**RE: St. Peter and Paul Church, 5800 Ouray Road NW
Grading and Drainage Plan
Engineer's Stamp Date 3-20-2015 (File: H11-D062)**

Based upon the information provided in your submittal received 3-20-15, the above referenced plan cannot be approved for DRB action on the Site Plan for Building Permit until the following comments are addressed:

OVERALL GRADING
AND DRAINAGE PLAN

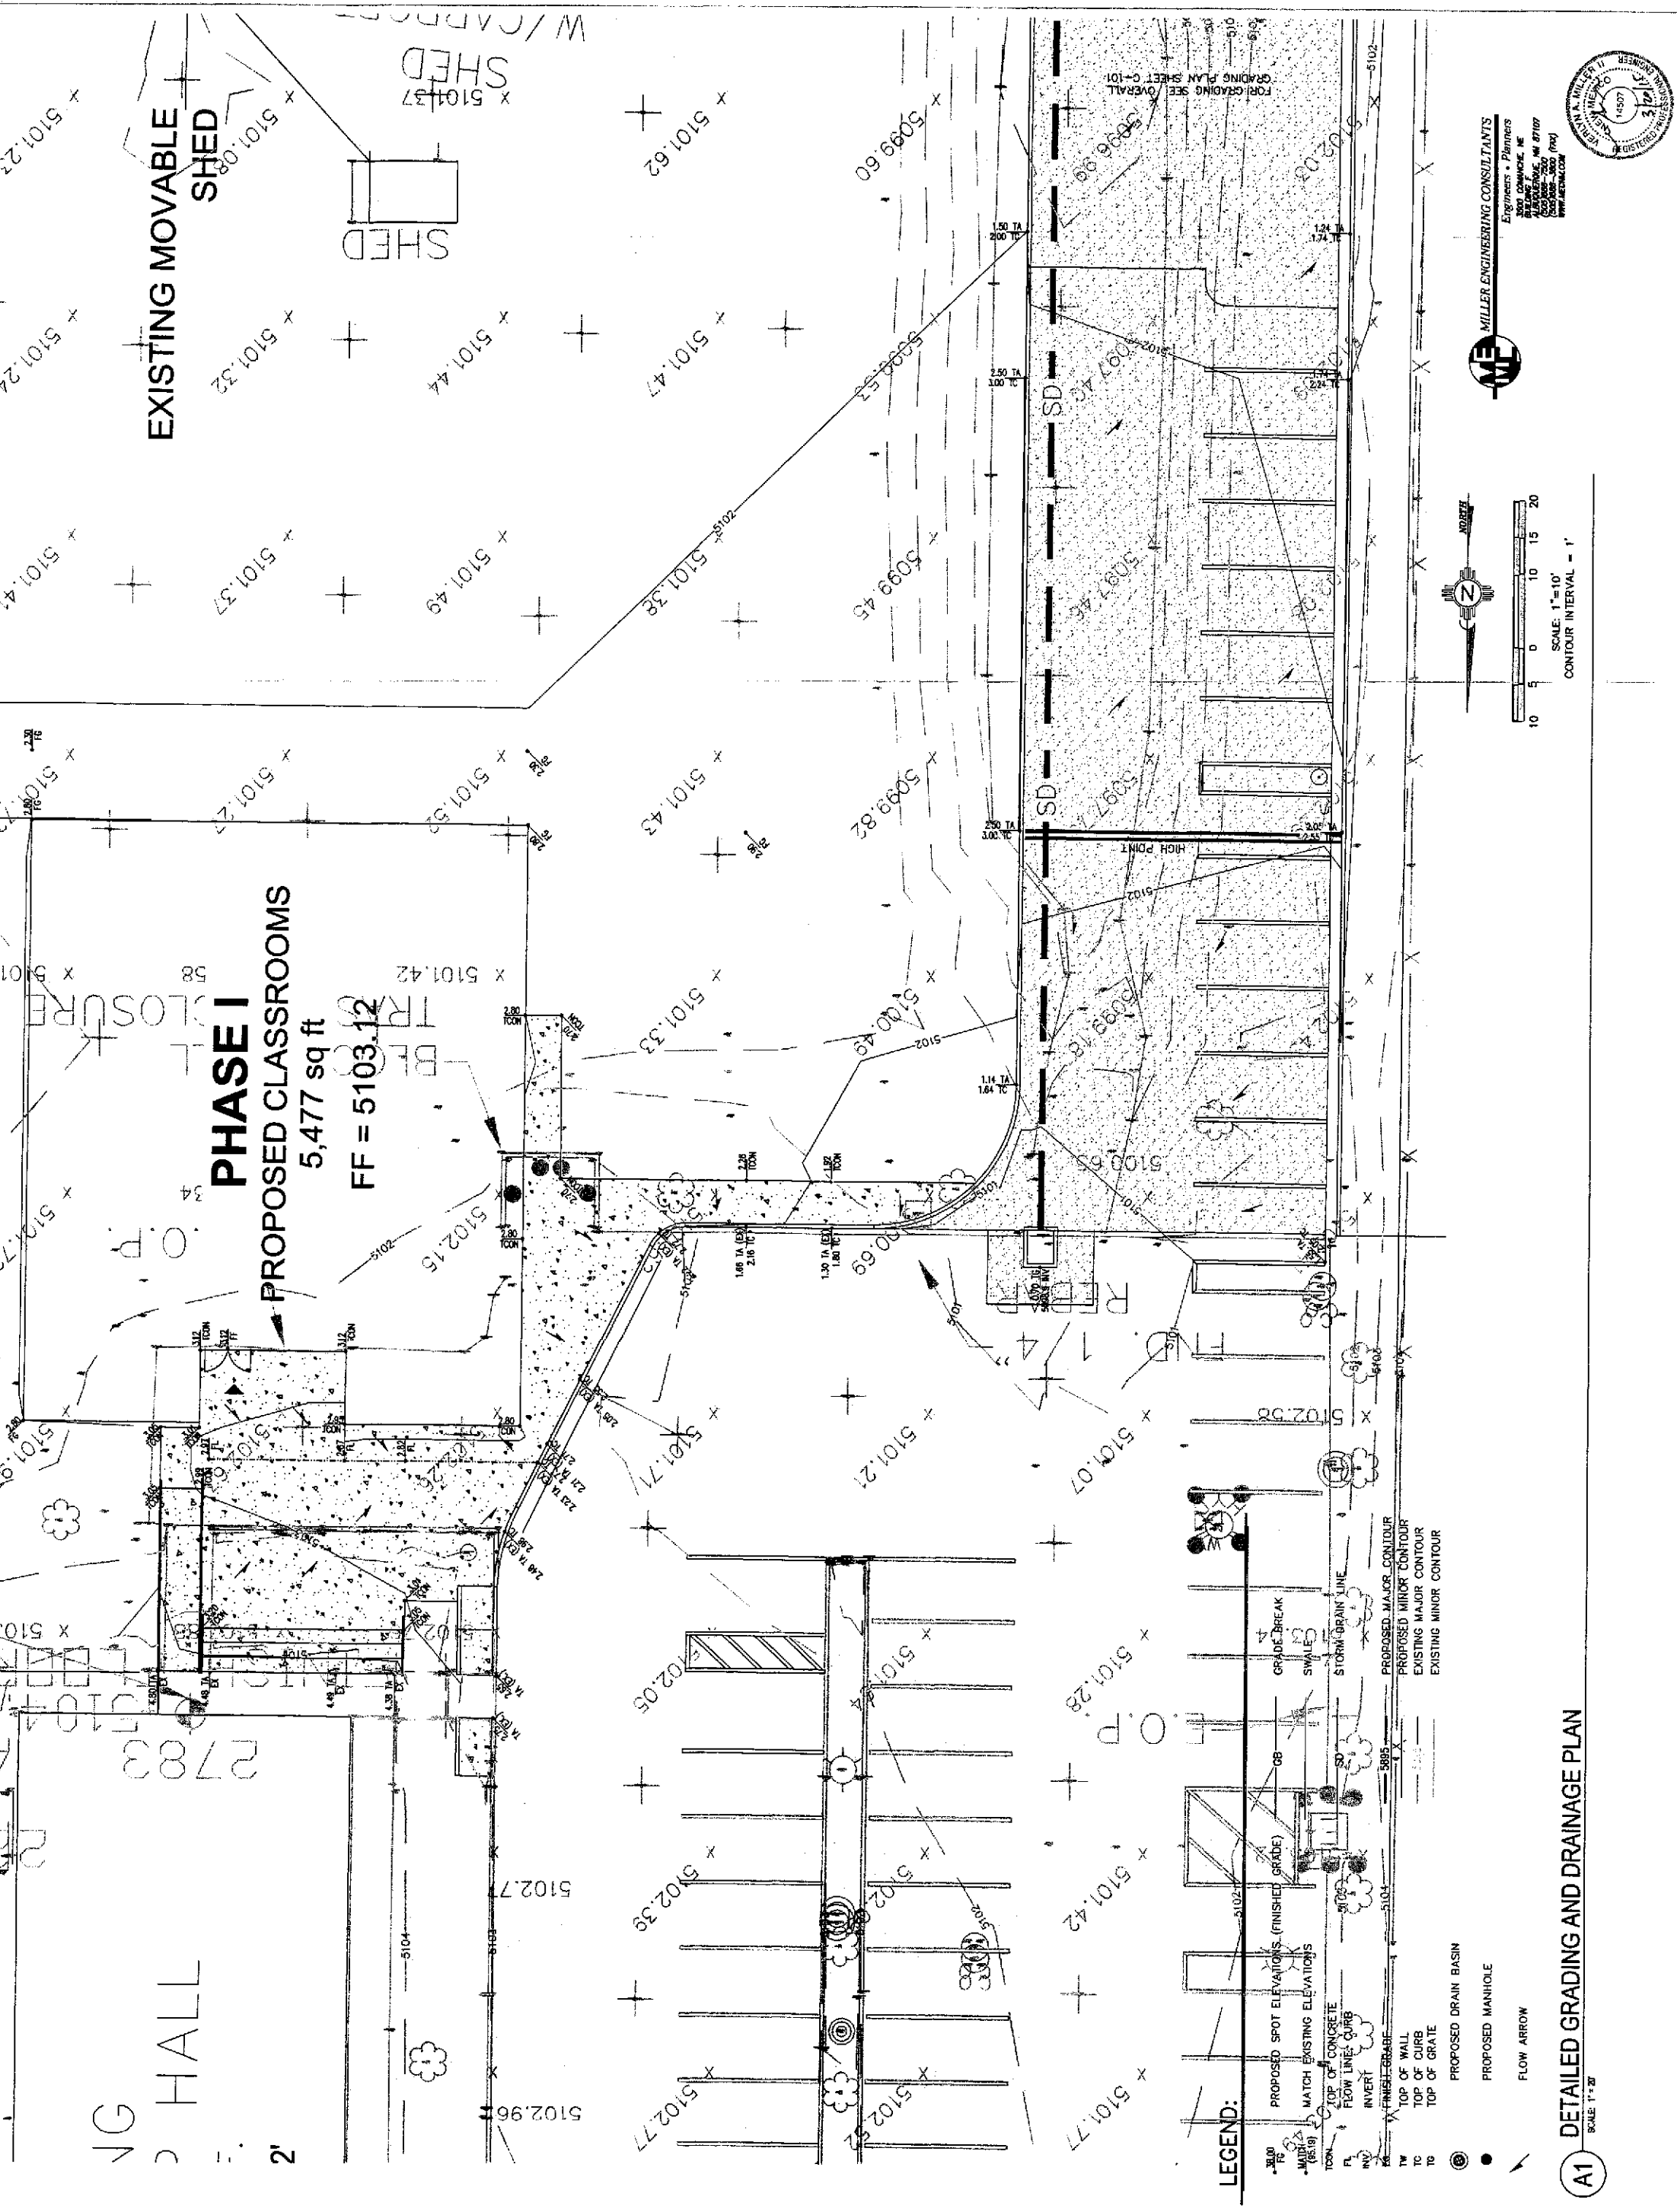
- 1) Highlight site on vicinity map, and show Basin A-1 and B-1 boundaries. In the Drainage Narrative, explain Basin A-1's ultimate discharge to the southwest corner of the property if this is the case.

- 2) In discussion of off-site flows, also mention any impact of on-site drainage to the property to the west and east or lack there-of. Provide more existing spot elevations along the western and eastern boundaries of the site.

- 3) For the new 12" pipe tie-in to the existing inlet at the southwest corner of the site, provide a downstream invert elevation, and show the invert elevation of this existing inlet to ensure positive flow to the storm drain in Miami Road. Show and label existing storm drain in Miami Road and the tie to the existing storm drain in Miami Road.

- 4) Label curb cuts where needed in low spots within the newly paved areas. It looks like a curb cut needs to be called out where Keyed Note 13 calls out a riprap rundown from the parking lot.

- 1) Keyed Note 17 for the storm drain is not called out on the plan view.
- 2) Is the top of grate elevation meant to be called out as 5100.70 on Keyed Note 16? If so, call it out, and double-check on pipe cover since with the listed pipe invert elevation, it appears that the pipe cover is less than a foot.
- 3) Show capacities, discharge flows, and pipe slopes for all proposed on-site storm drain pipes. Show capacity of new on-site inlet. For any proposed curb cuts, also provide capacity calculations.
- 4) For the proposed pond, label complete pond volume and WSEL Elevation.
